COUNTY OF COLUSA, CA

Request For County Board of Supervisors Action

MEETING DATE:	**February 25, 2025**
DEPARTMENT:	**Community Development Department**
FROM:	**Xzandrea Fowler**
SUBJECT:	**Public Hearing for the Janus Solar and Battery Storage project's Final Environmental Impact Report, Mitigation Monitoring and Reporting Program, Use Permit #PD-24-24, Williamson Act program compatibility determination, Development Agreement Ordinance, and Franchise Agreement Ordinance.**

Figure 3:Site-Specific Wildfire Hazard Potential. Source: Pyrologix, 2021

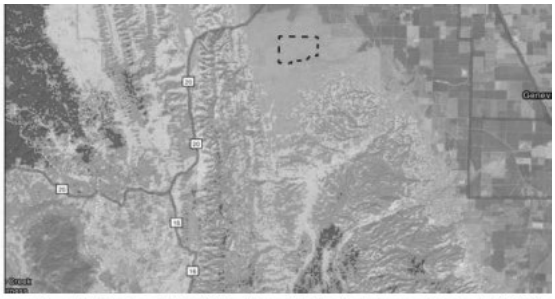
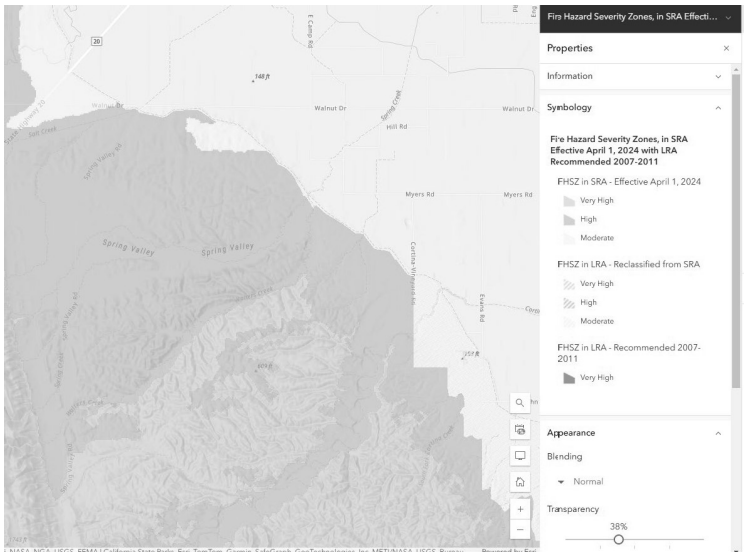
One needs to ask why Janus chose to use a private company (Pyrologix, 2021) analysis of fire risk rather than CAL FIRE or seek out a state agency's opinion on the fire risk when doing their presentation to the Planning Commissioners. The map shown below is from a private firm showing 2021 data analysis.

When location site entered into CAL FIRE mapping (see below) it showed location as HIGH risk.

The FEIR fails to explain in sufficient detail to allow the public to comment on the project's specific fire prevention plan and mitigate strategies and any specialized or site-specific tailor fire code unique to that site and the proposed facility along with established periodic monitoring for compliance. Do the wind conditions in Spring Valley remain "under 40mph conditions" as purported in the Janus analysis presented to the Planning Commission?

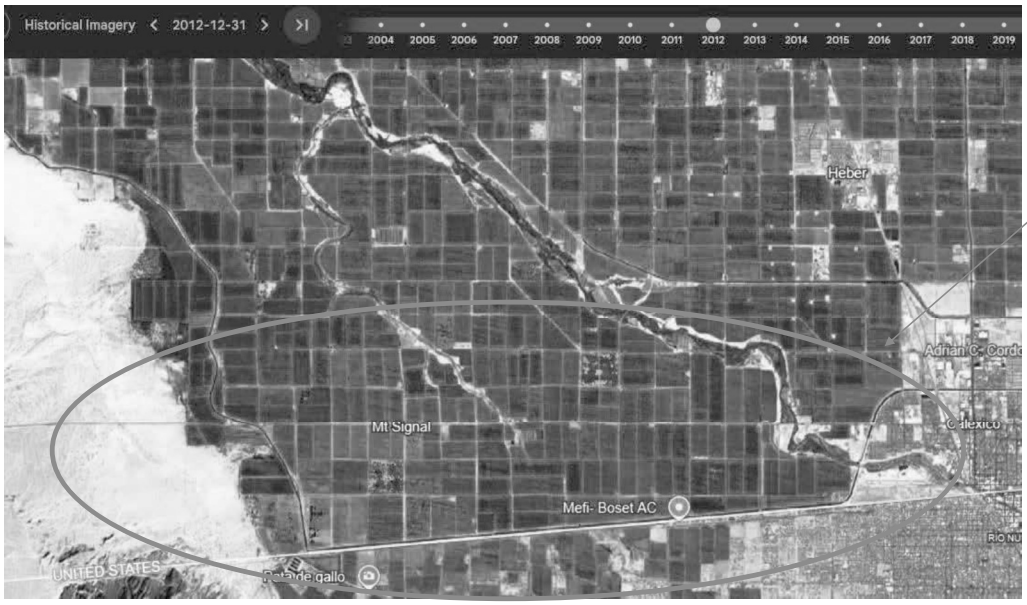
DEIR needs to analyze relative to **zone of influence** and loss of farmlands as required by CEQA. By not including solar developments into the LESA analysis, it leads to incorrect analysis relative to farmland loss as well as foreseeable environmental impacts.

Moreover an alternative site analysis is insufficient and lacks compliance with CEQA.

Impact of Solar to Mount Orab, OH, from 2017 to 2022; **LESA model in DEIR does not account for solar & ZOI**.

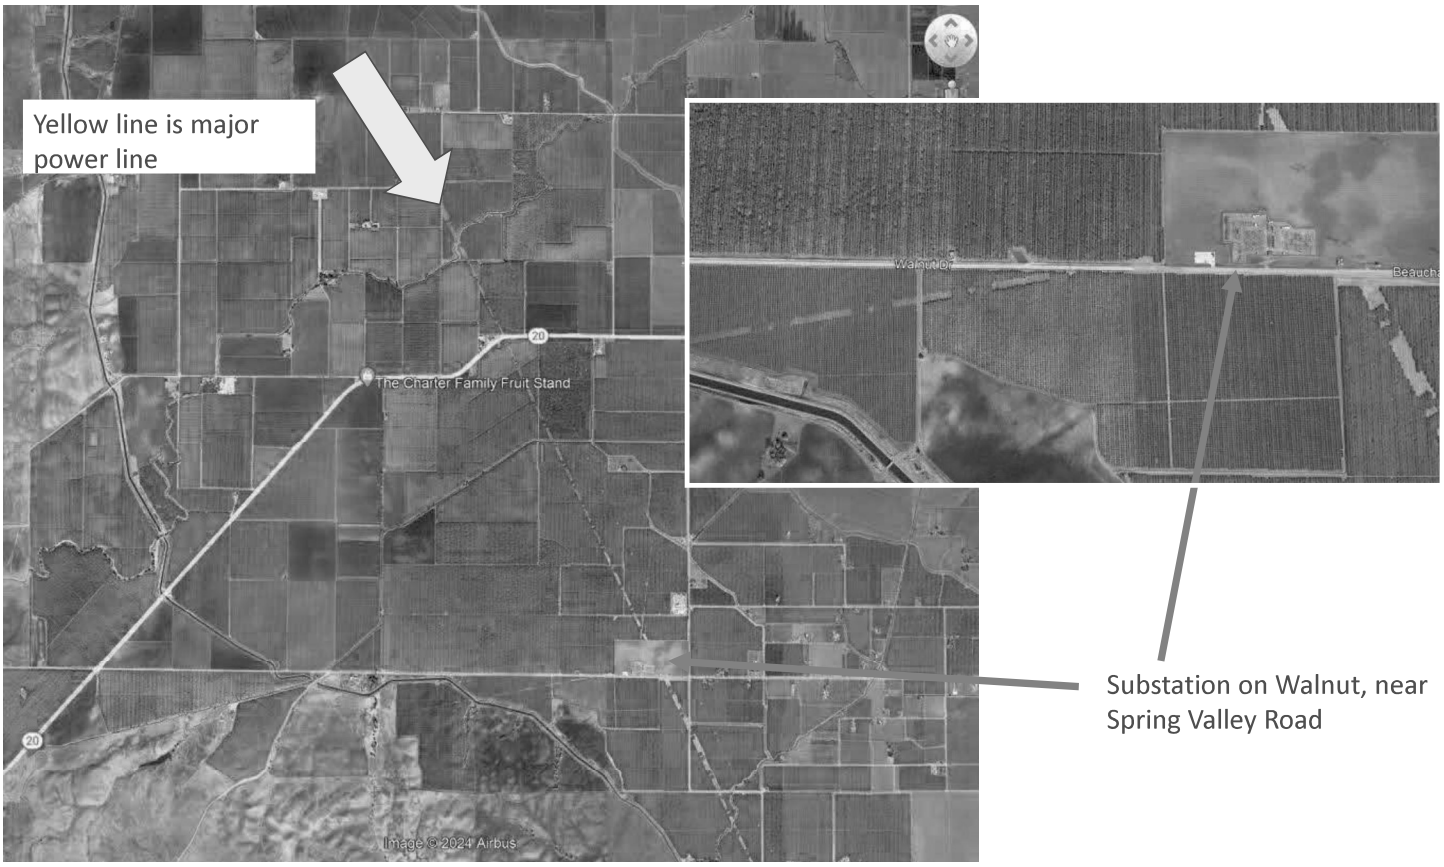
Last update (correction) to LESA model Appendices A and B (**dated 2011**) per Conservation.ca.gov;. Does the DEIR modeling account for changes to solar development; what and how do factor weight impact analysis, ZOI, and are they current and being applied correctly?

Substation on Walnut, near Spring Valley Road

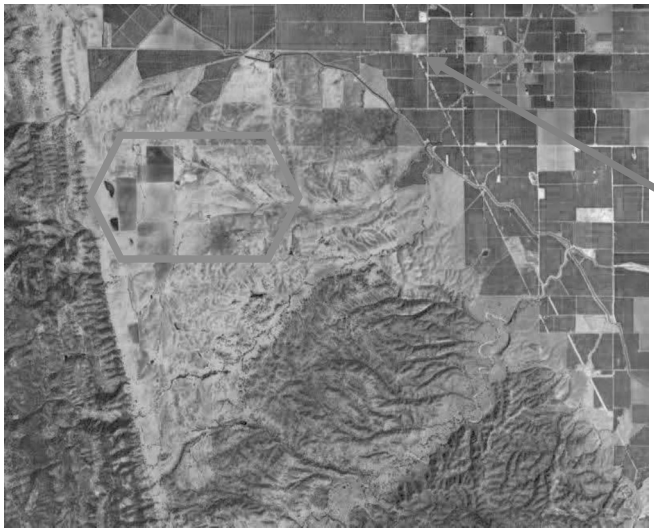
- Any Permit, County General plan or ordinance needs to anticipate & correctly model impacts of utility size (large scale) solar developments occurring, particularly if there is a main electrical conduit, substation and/or Gen-tie in nearby. In the aternative site analysis, infrastructural needs was not complete.

Red outlined areas may become solar lands and no longer farmland due to zone of influence by initial >600 ac solar facility and Gen-tie in; could also include south of displayed location below.
